ENGINEERING RECORD
DRAWINGS

WALDEN PRESERVE 2
Filing No. 4
Construction Drawings
El Paso County, Colorado

WALDEN PRESERVE 2
Filing No. 4
Grading & Erosion
Control Plans
El Paso County, Colorado

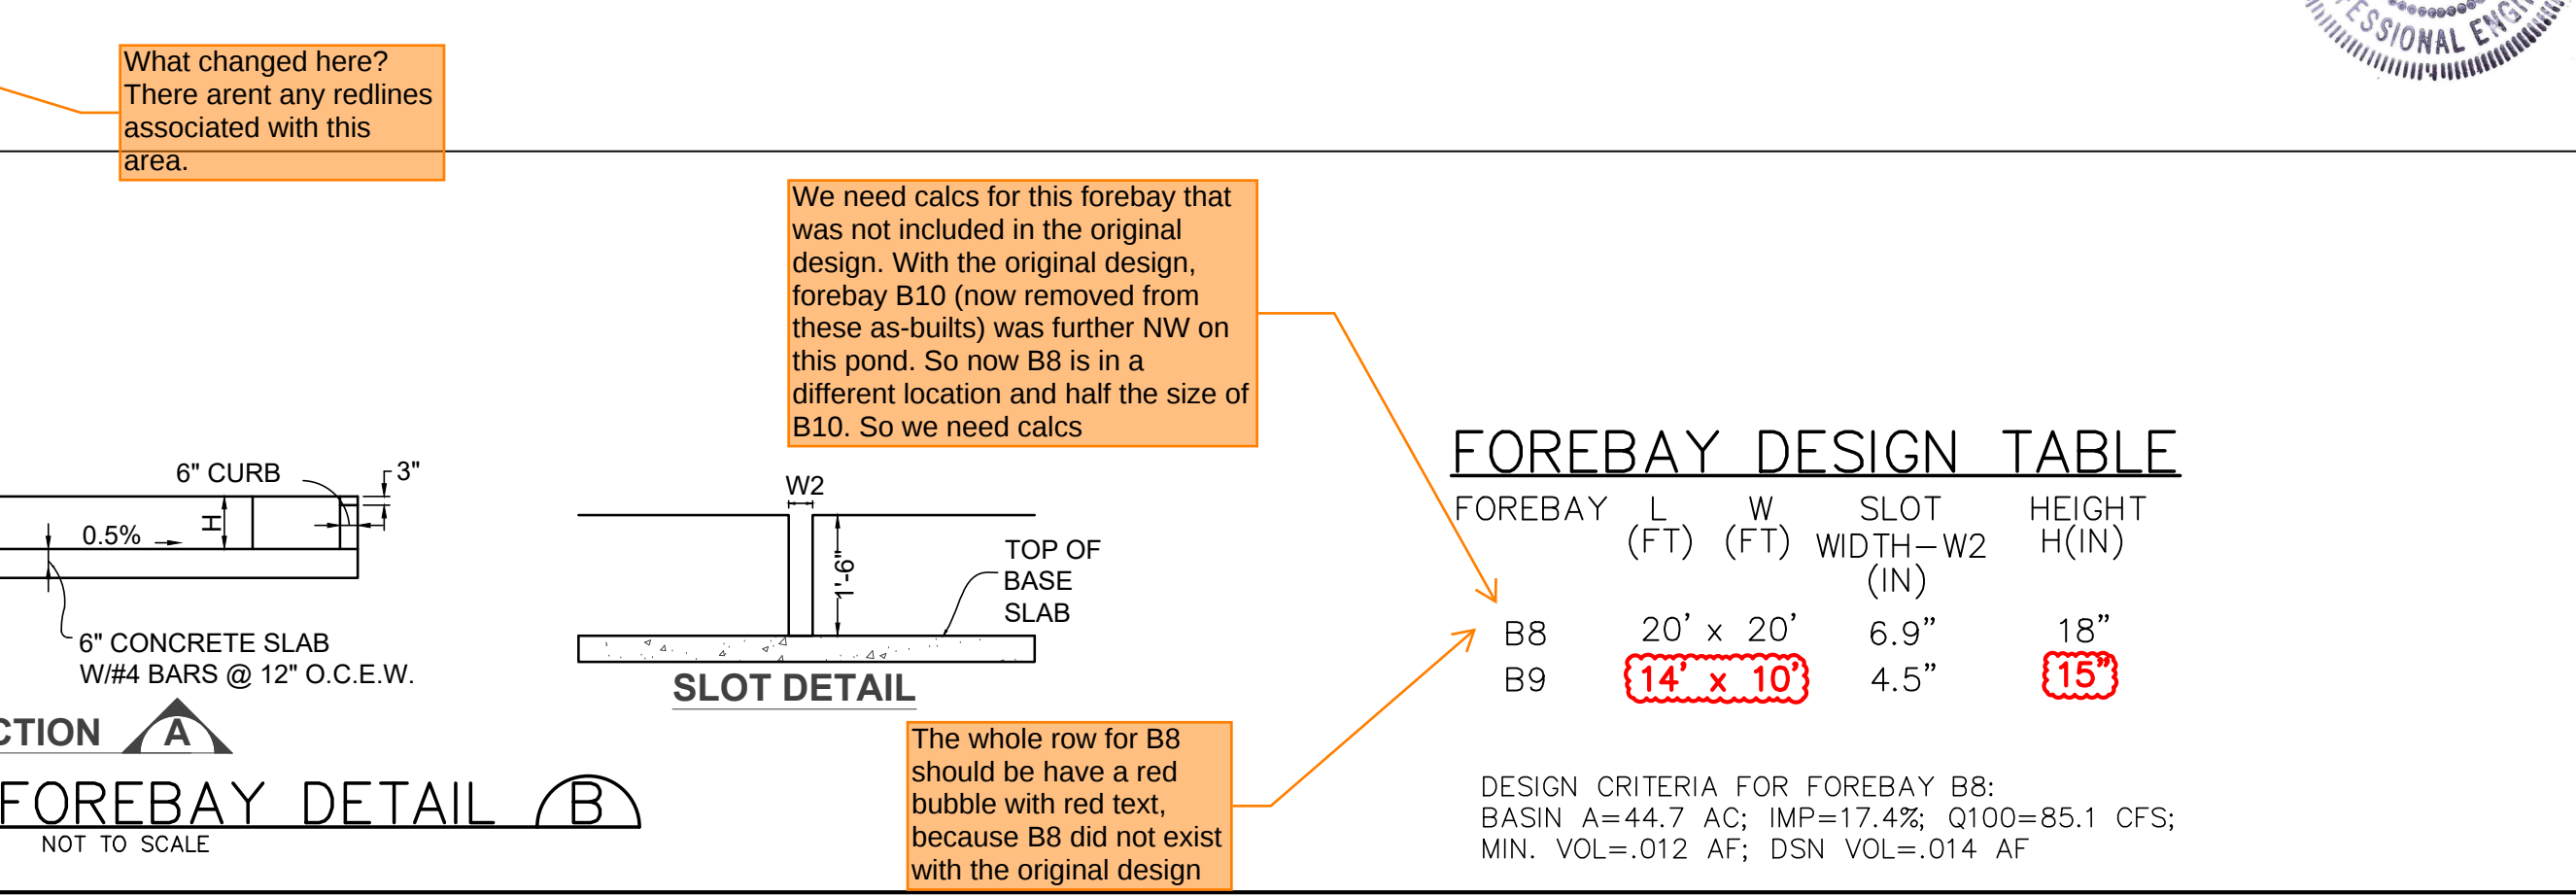
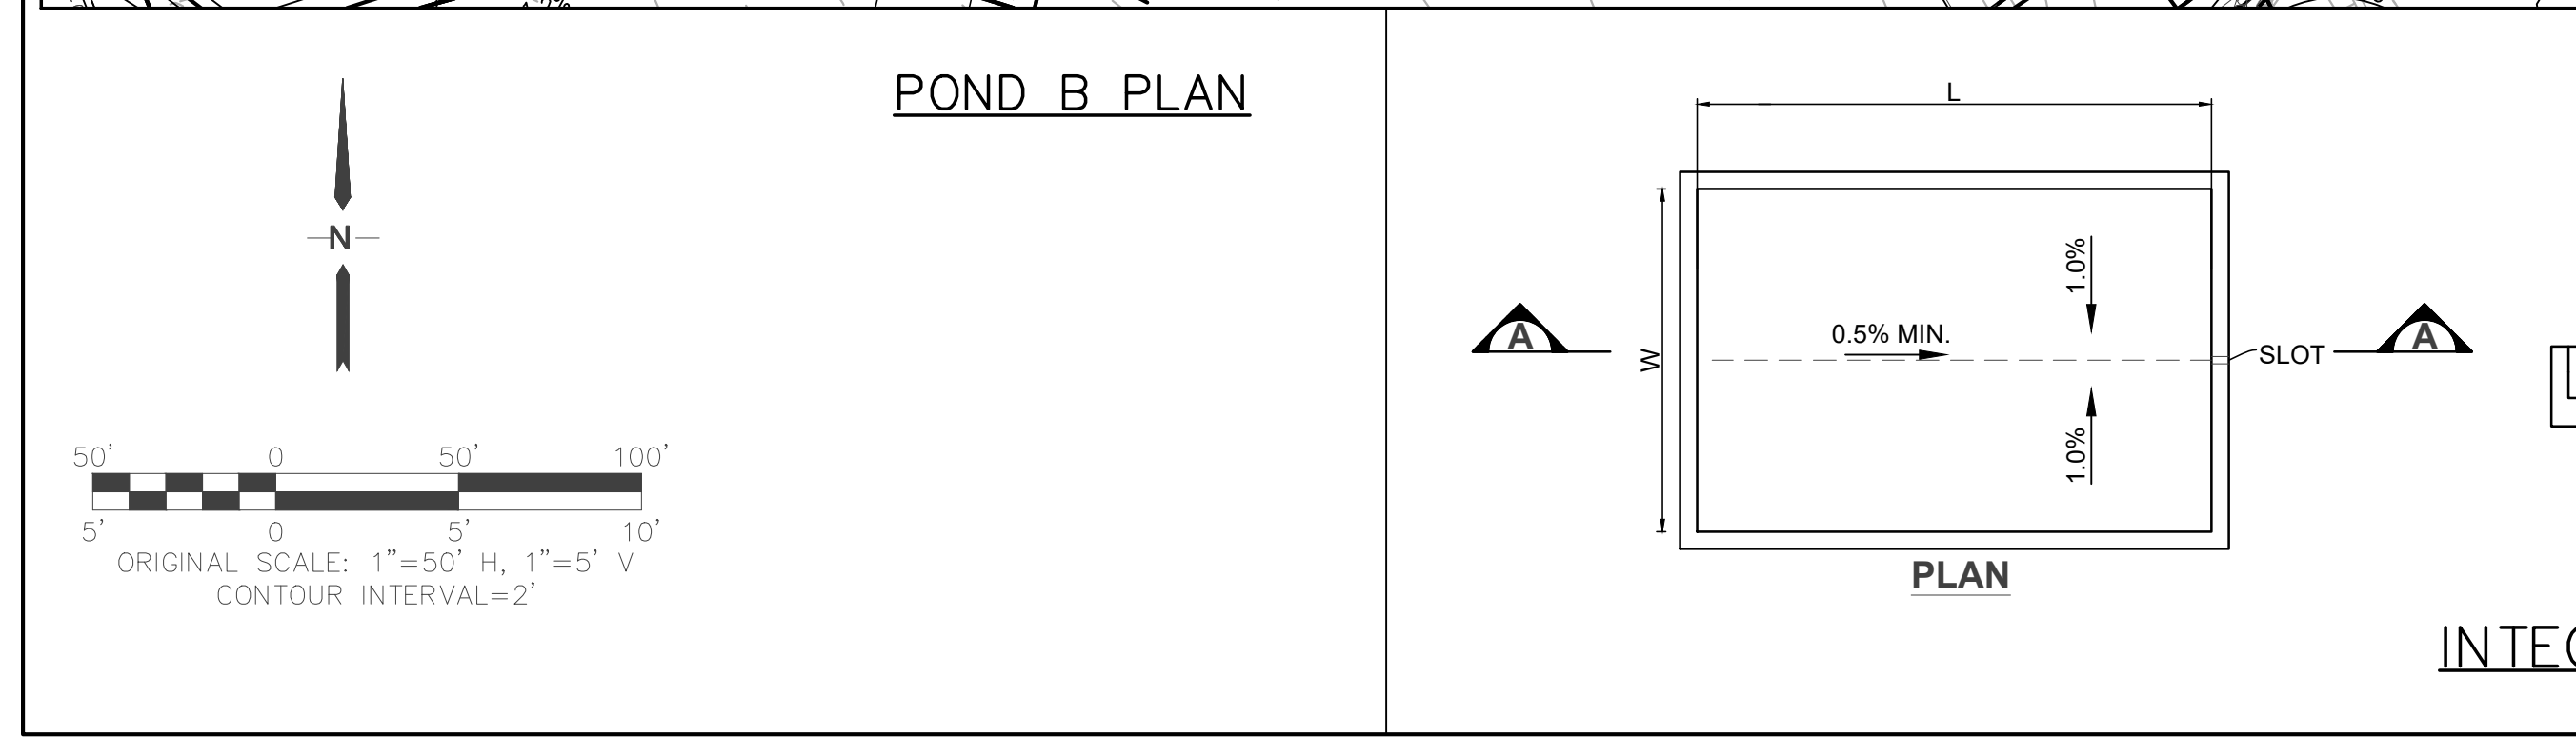
The signature block for Engineering Record Drawings that was here with the last submittal was removed. Please add it back.
